RE: RESPONSE TO REQUEST FOR ADDITIONAL INFORMATION

DA2024/1806

26A LAKEVIEW PARADE, WARRIEWOOD

Demolition works and construction of a garage and secondary dwelling at 26A Lakeview Parade WARRIEWOOD.

Figure 1: Northern neighbouring property at No. 6b Elimatta Road, with view availability indicated.

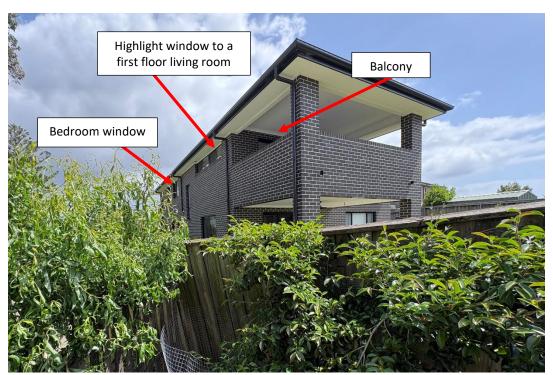
Views to the south coastline for nearby dwellings, also addressed in the submission by Tuszynski, are through a side boundary to Long Reef Headland, over 5km away. The view to the south coastline and Long Reef Headland is considered secondary to the primary view of the neighbouring property at 6b Elimatta Road to Warriewood Beach. This is due to the neighbouring property at 6b Elimatta Road, which has a balcony facing east to Warriewood Beach. Although it is acknowledged that 6b Elimatta Road includes windows that are orientated towards 26A Lakeview Parade (the subject site), these windows are relatively small in size and act as vectors for natural light to enter the building as opposed to providing opportunities for views towards the coast. Refer to Figure 1, which demonstrates the uses of the spaces that views are available from.

The view analysis has been prepared based on an average-height person standing and has taken into consideration the revised levels under the amended proposal. The key modified built element introduced is the reduction of height by 1.362m compared to the previous design. Additionally, the height of the secondary dwelling has been further reduced by the fact that a greater setback to the rear boundary is now proposed, shifting the secondary dwelling forward where the natural ground level of the site is lower. This is illustrated in the View Diagrams prepared by Pagano Architects.

The planning principle acknowledges that the protection of views across side boundaries are *more difficult to protect* compared to views from front and rear boundaries. The key viewing points from adjoining neighbours are from an outdoor balcony, highlight windows from a living room and a window from a bedroom, with the affected view being across the side boundary; to quote *Tenacity*, 'The expectation to retain *side views* and sitting views is *often unrealistic*'.
